Shiprock Pinnacle Hotel & Restaurant

Highway 491 & Turquoise LN, Shiprock, NM 87420
Dyron Murphy Architects Project No. 2022.10

ADDENDUM No. 3

December 15, 2023

SIGNAGE SCHEDULES, TYPES AND MOUNTING

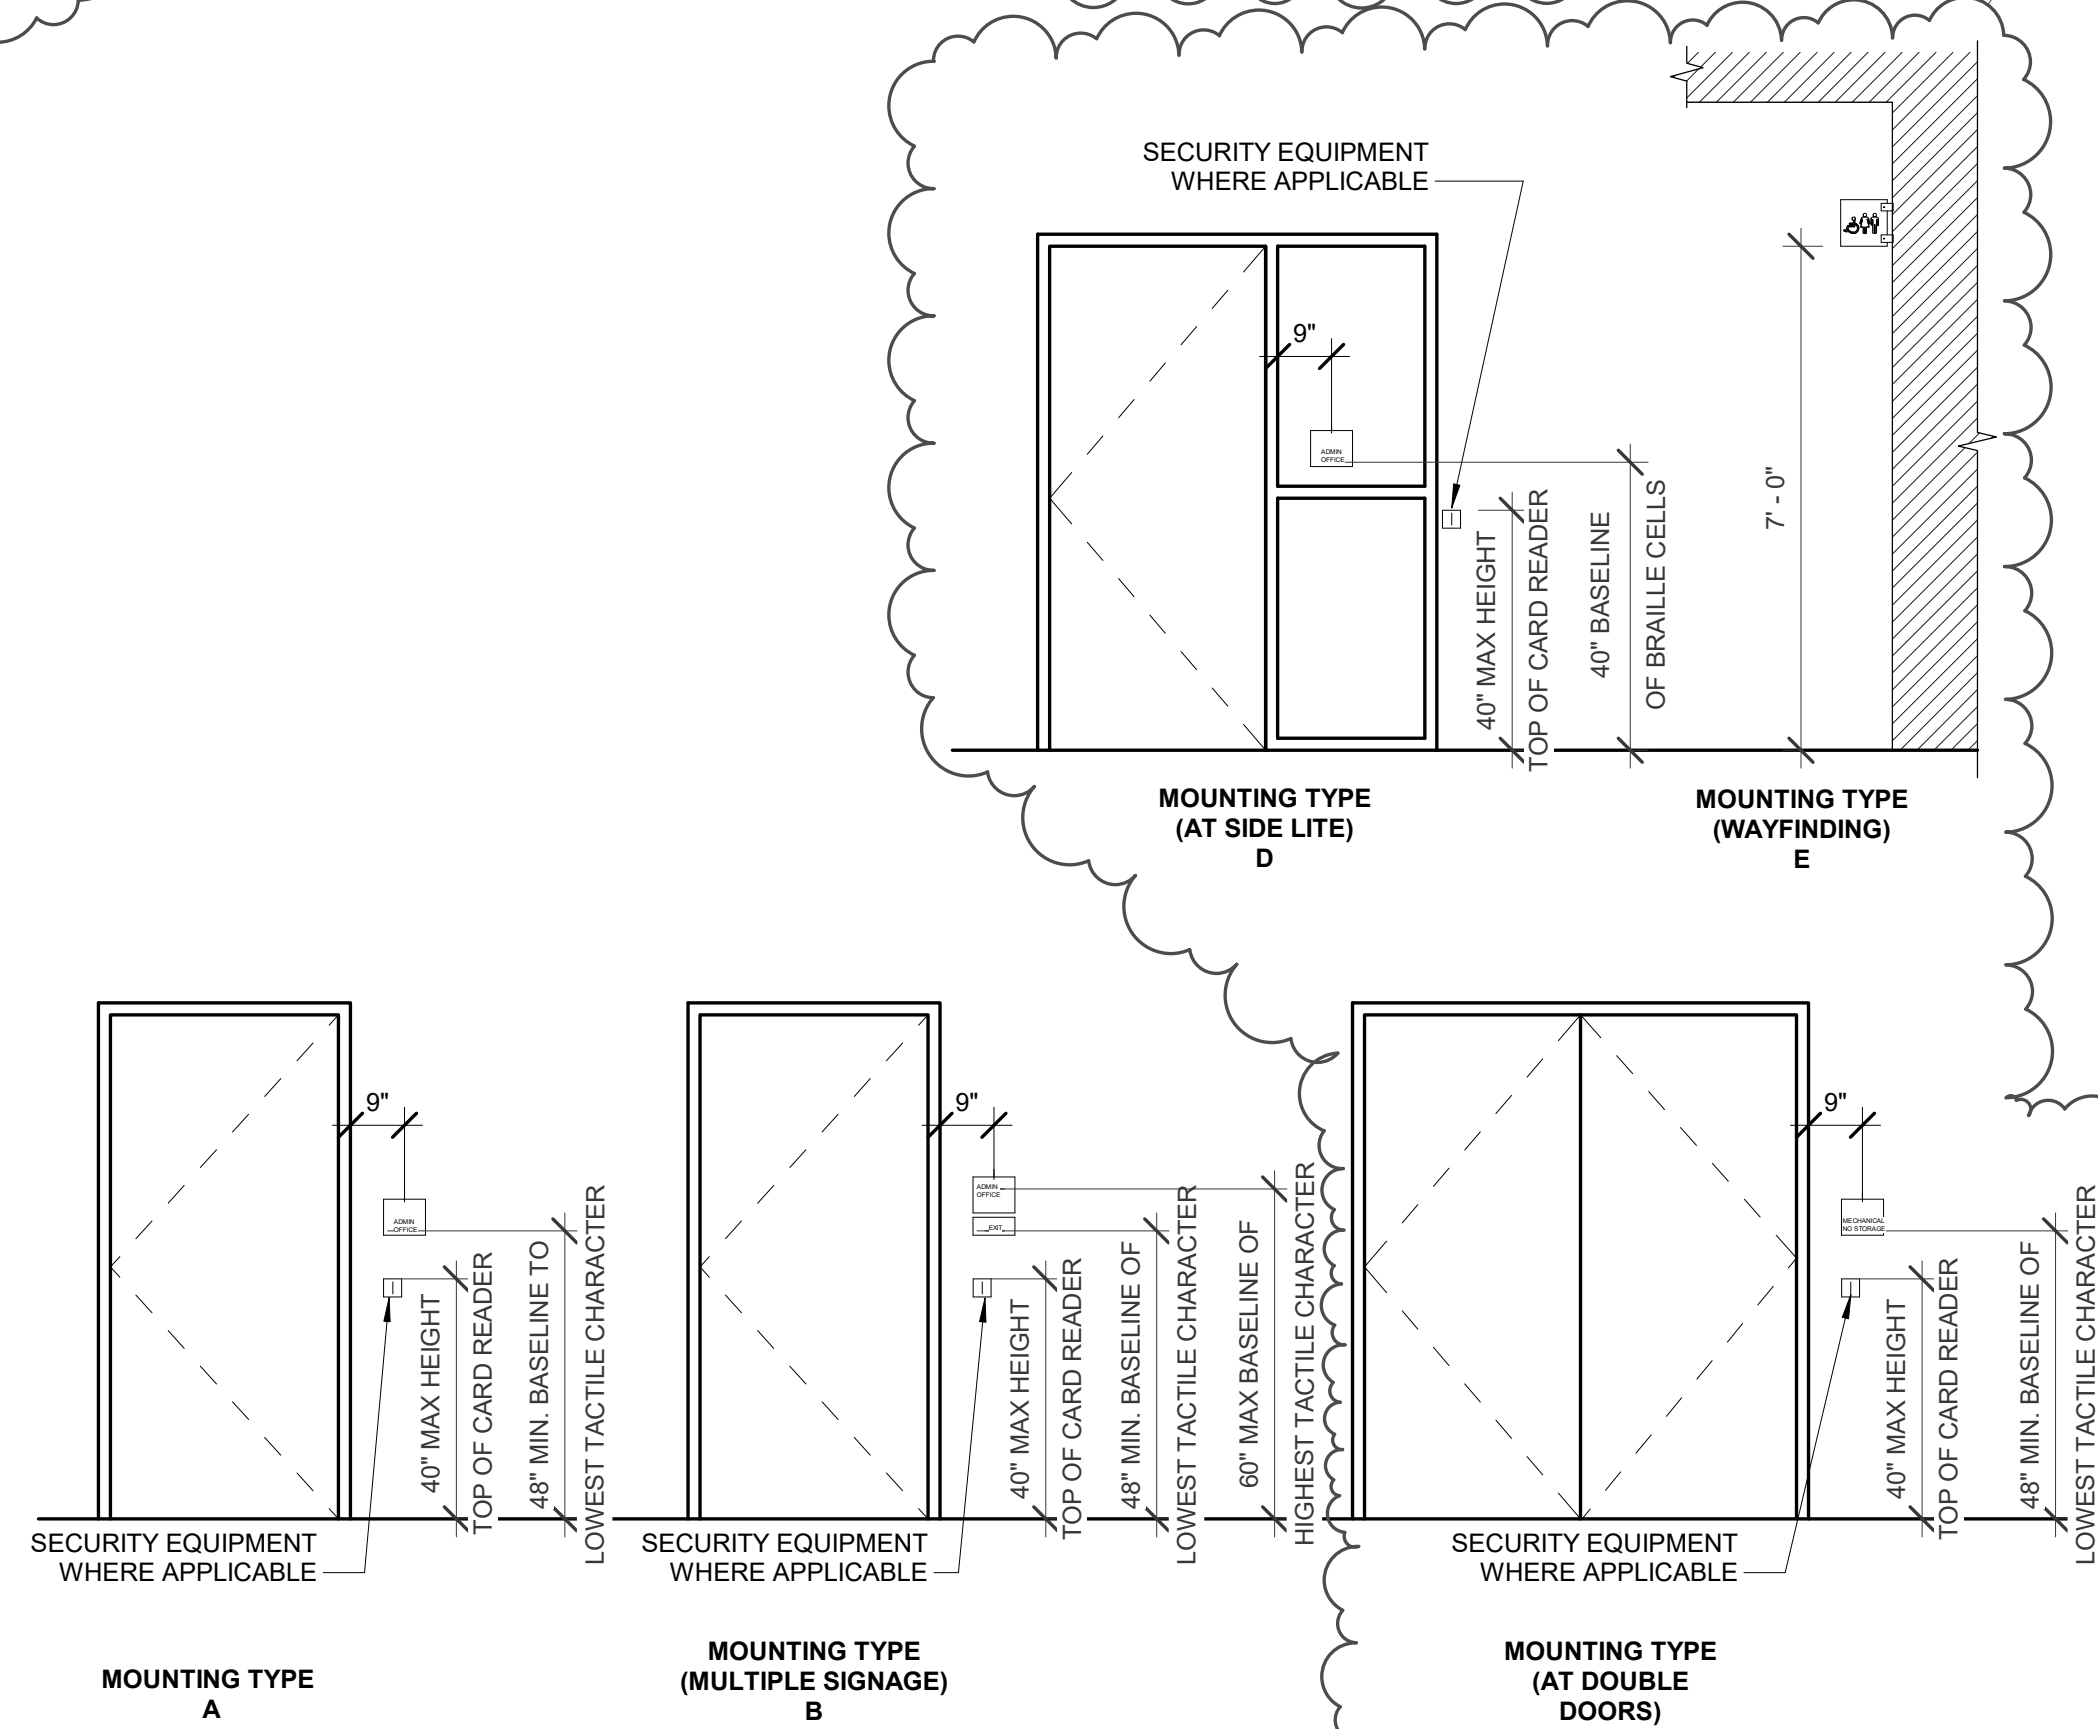
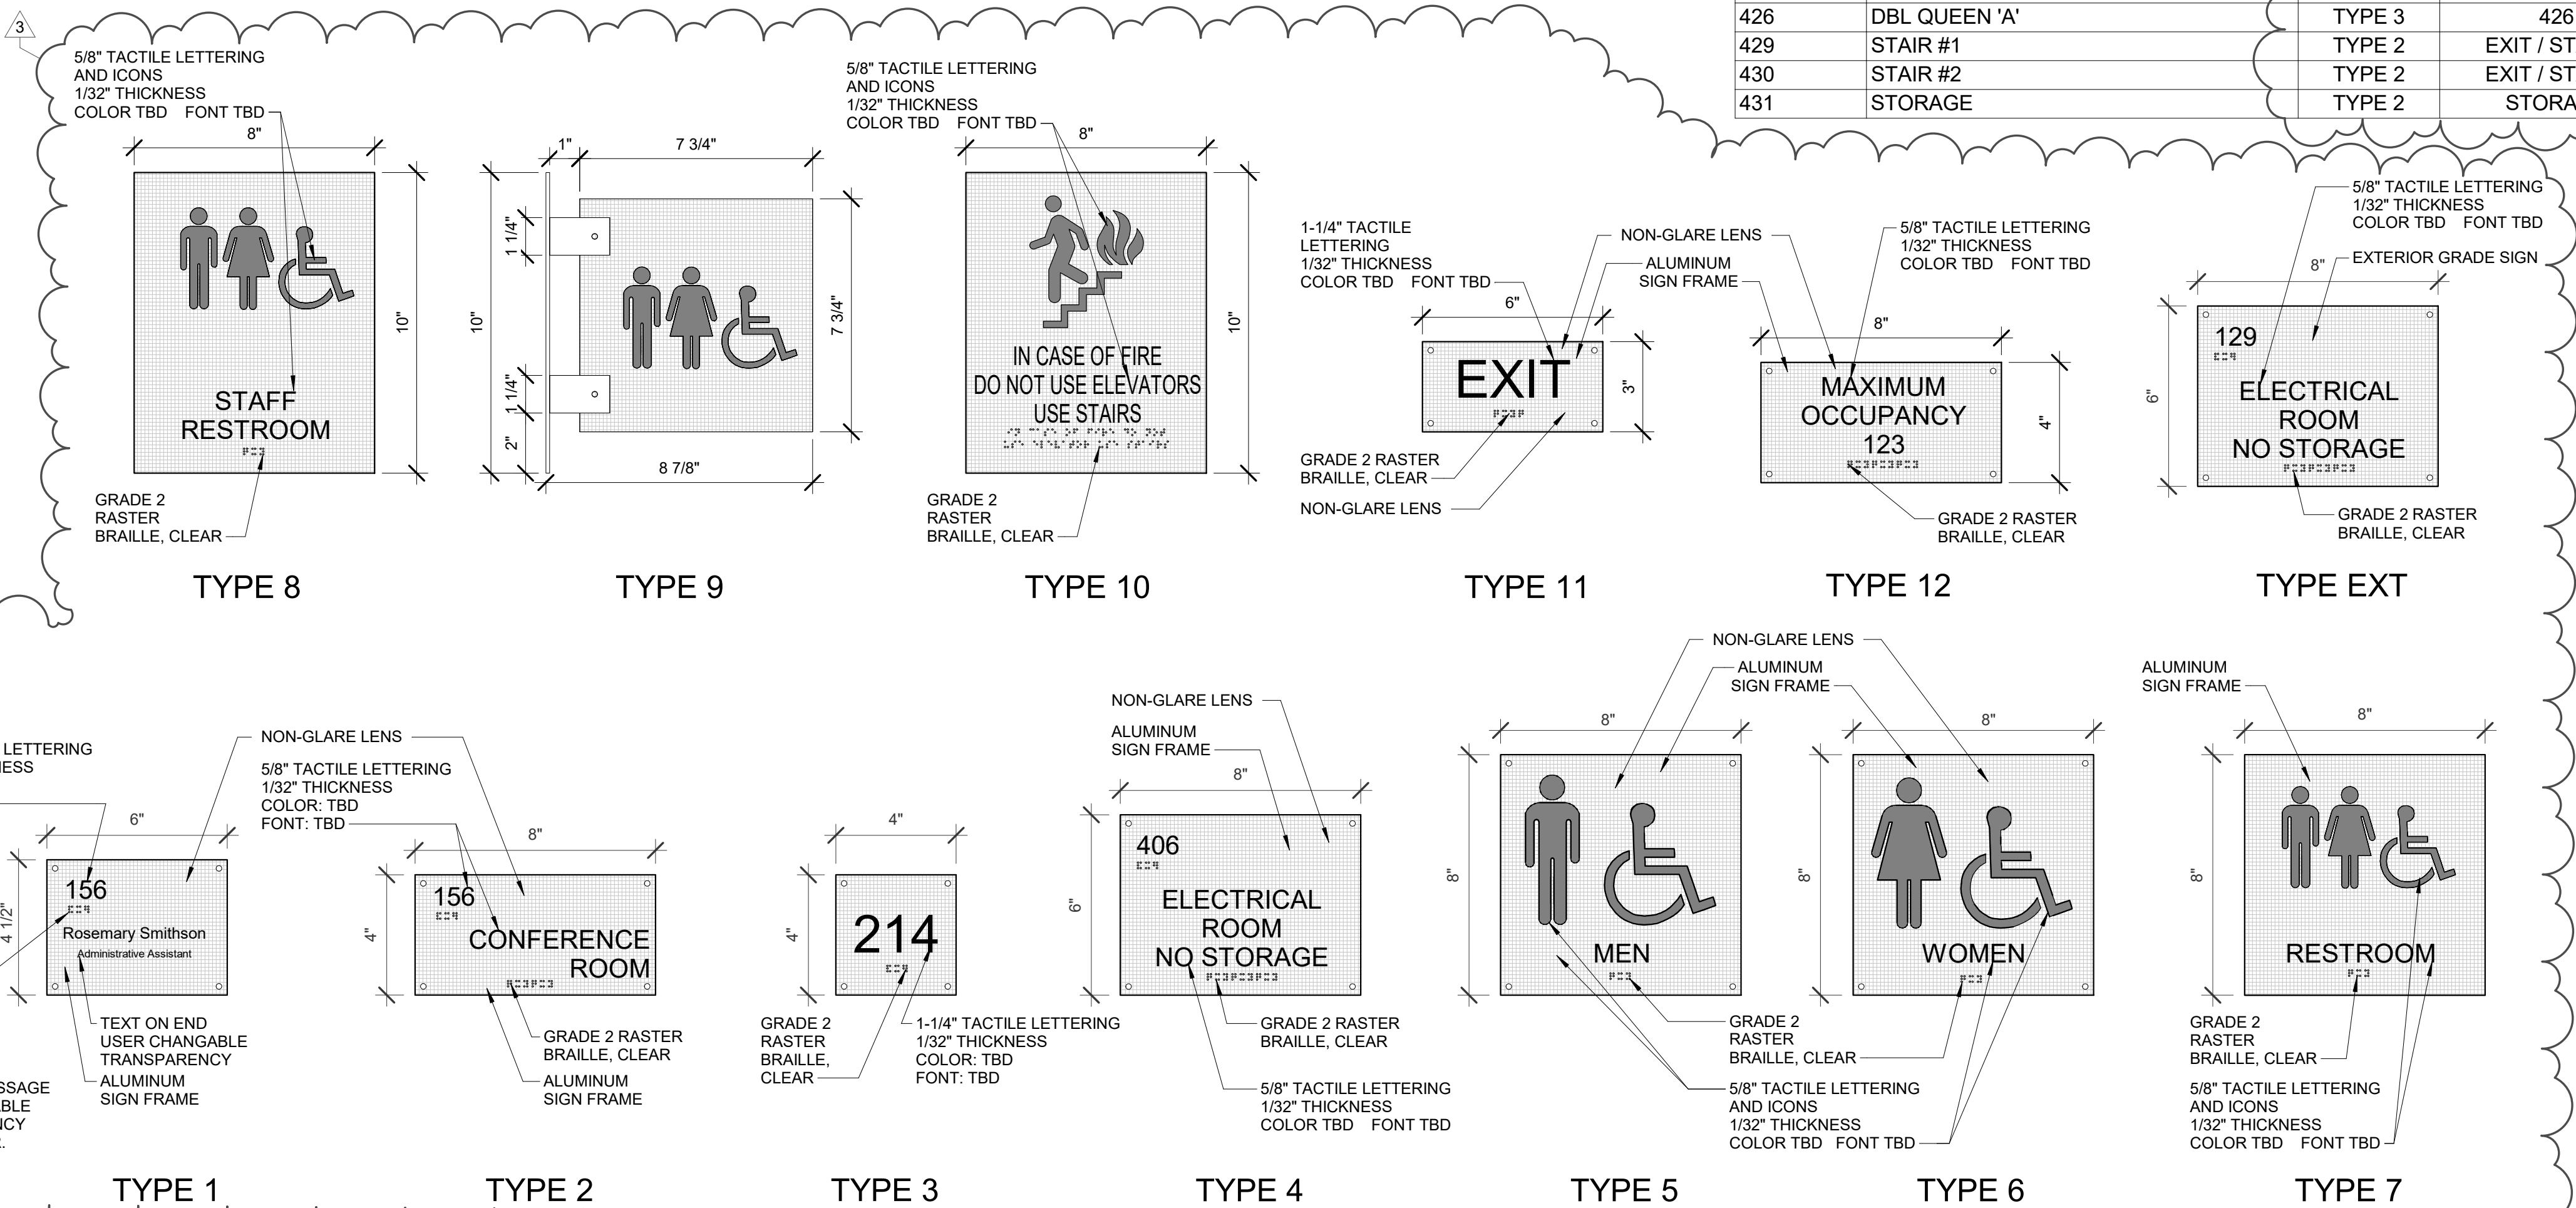
3. *Sheet ID106 Signage Plan. Signage Legend – asks for alloy sign system. ID201 Signage Schedules Types and Mounting, Detail A6 Sign Types – depicts an Aluminum frame (CSB Diversity system) and flat acrylic sign system (CSB Basic system). Please confirm which sign system is to be quoted?*

4. *Sheet ID201 Signage Plan. Signage Schedules. Sign Types list all signs to be Type S1. Please confirm that this is incorrect.*

ID201 – SIGNAGE SCHEDULES, TYPES AND MOUNTING

- Revised 'Sign Type' & 'Sign Message' on Signage Schedules.
- Revised Sign Schedules to include signs called out on floor plans.
- Revised Sign Types detail A6/A201.

Sign system shall be alloy system. See updated revised sheet ID201.

Confirmed. Sign types have been updated. See attached re-issued updated sheet ID201

1-HR WALL AT CEILING/FLOOR

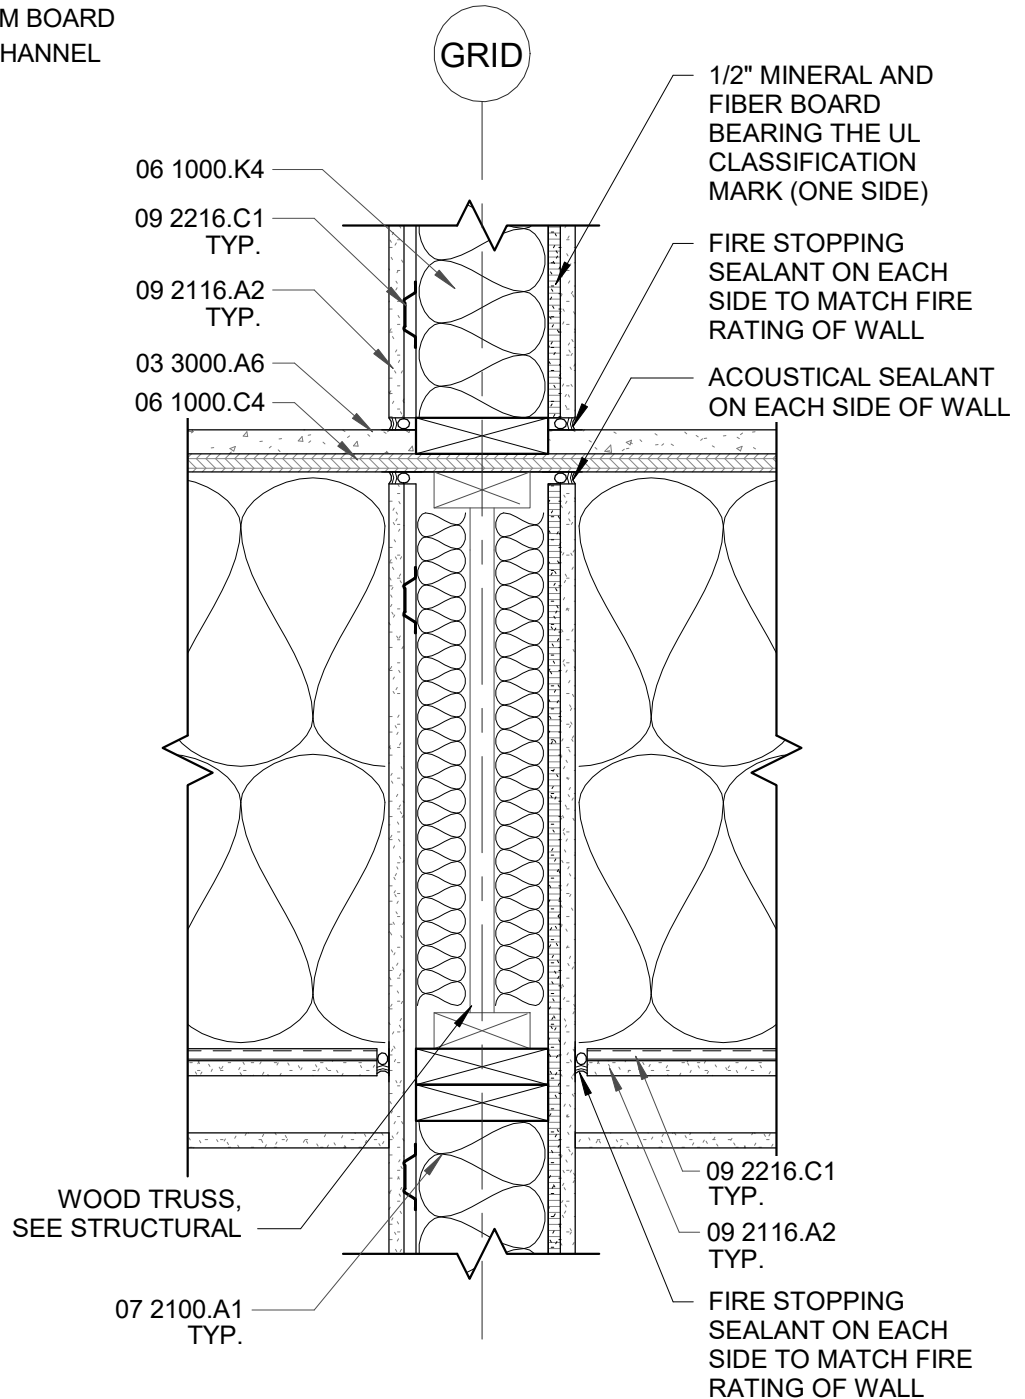
1. *Do the Fire Rated Walls get Fire Caulk to the Fire Rated Floor/Ceiling & Roof/Ceiling Assembly per UL System HW-S-0088? The Drawings are not detailing that intersection specifically.?*

SKETCH A04 – 1-HR WALL AT CEILING/FLOOR

- Added Detail of interior rated wall at rated ceiling / floor.

Yes, fire rated walls will require fire sealant where the top of the wall meets the underside of the floor/roof decking. See detail provided on attached sketch A04.

B6 PARTIAL SOUTH ELEVATION - B6/A203
3/16" = 1'-0"

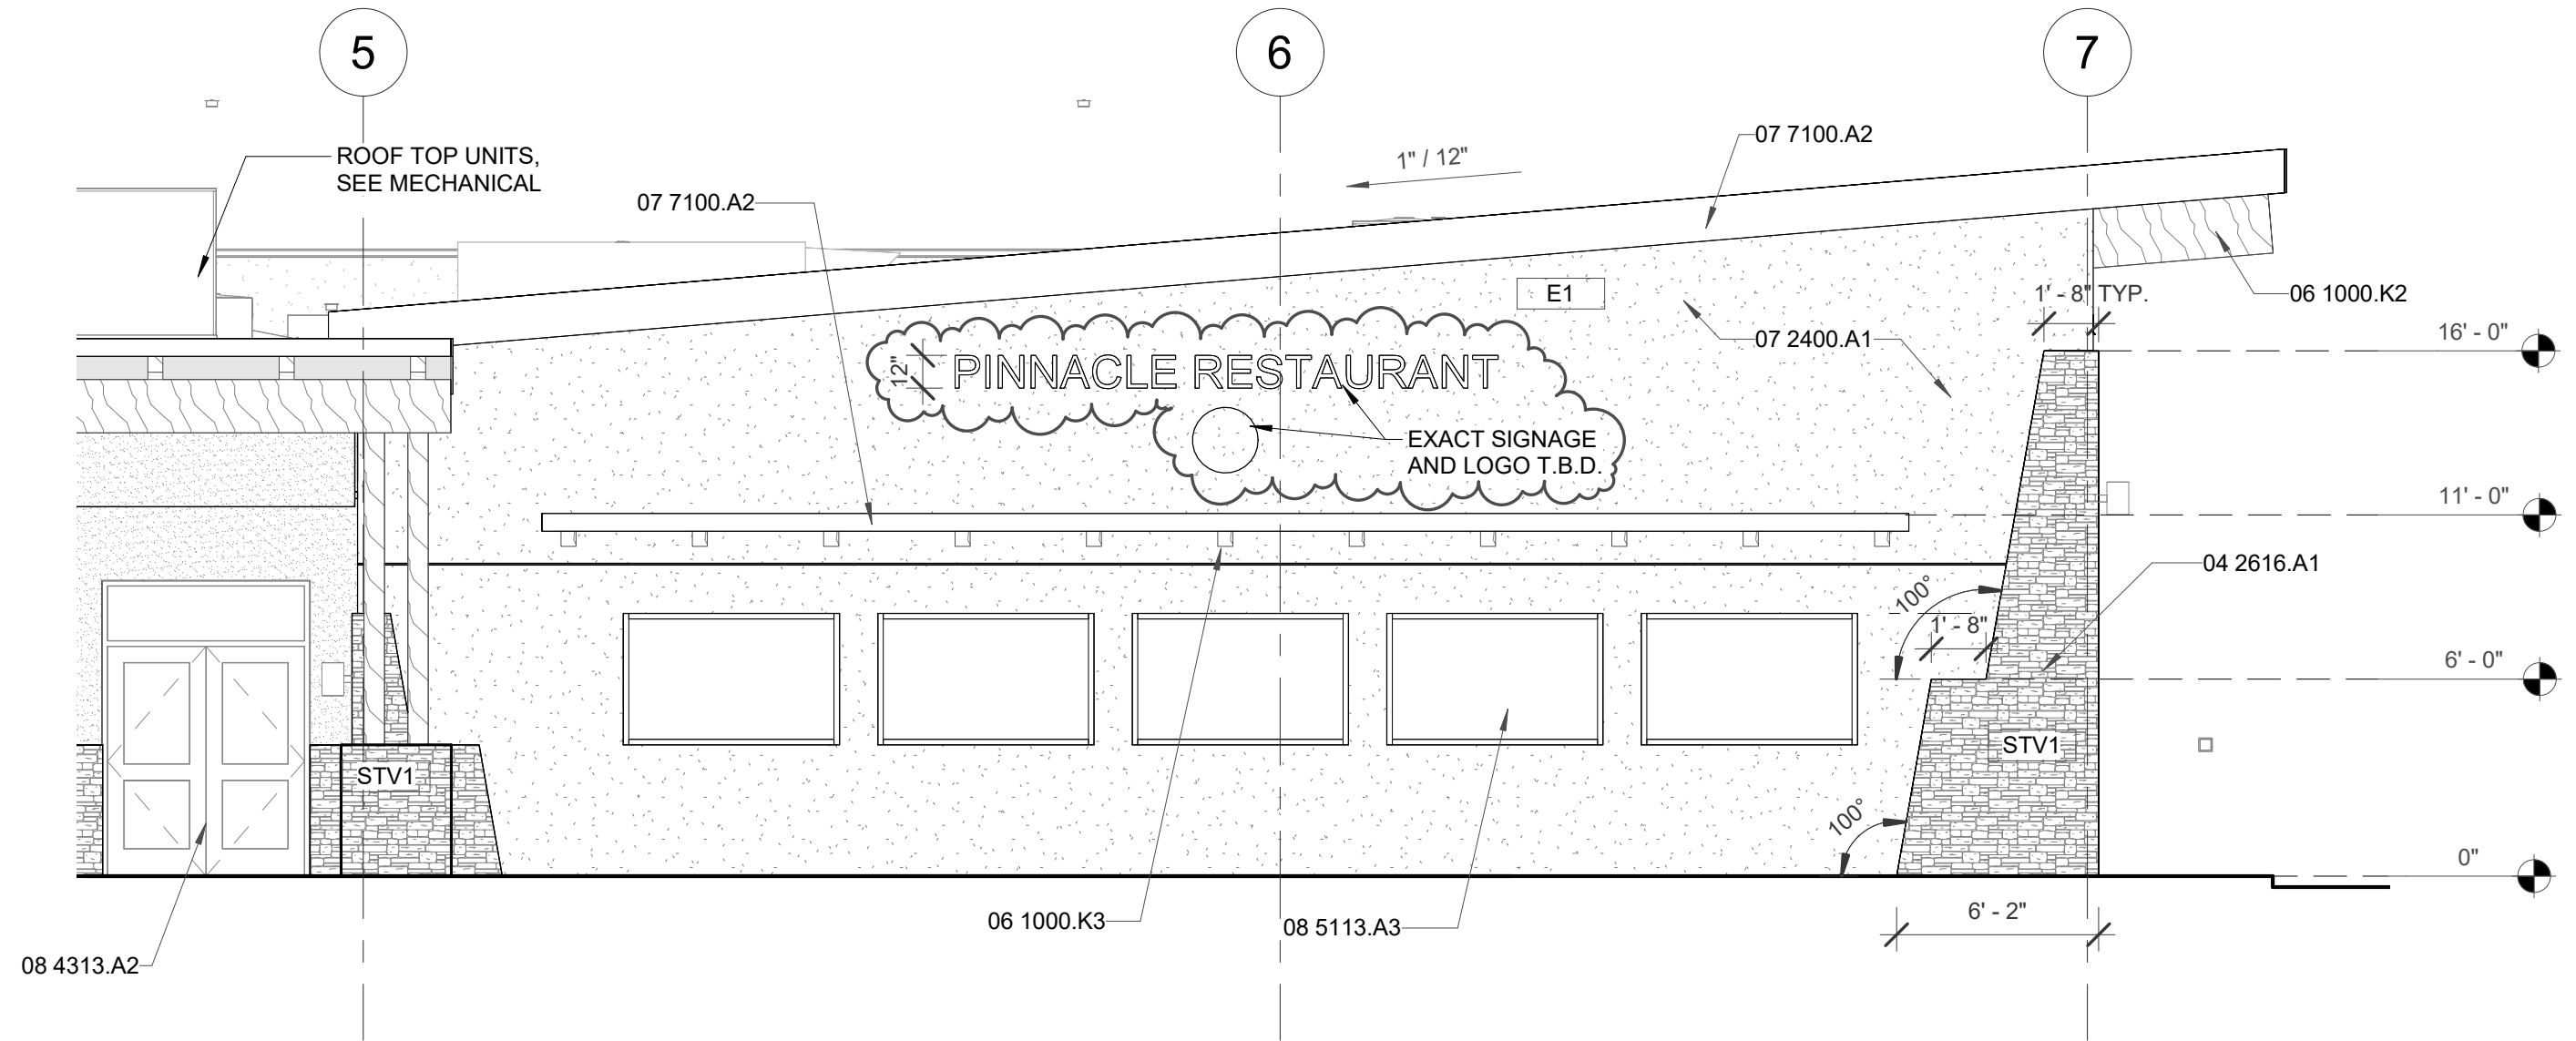
8. *Please confirm if Exterior Dimensional Letters should be quoted for Restaurant. Is the intent for them to be illuminated? If so, is the intent to be back-lit or face lit?*

SKETCH A05 – EXTERIOR SIGNAGE – RESTAURANT – A203

- Added exterior signage to restaurant south wall.

Exterior dimensional letters are to be provided on south wall. Owner to confirm if sign will be face lit or back lit. See Sketch A05 for updated elevation B6/A203.
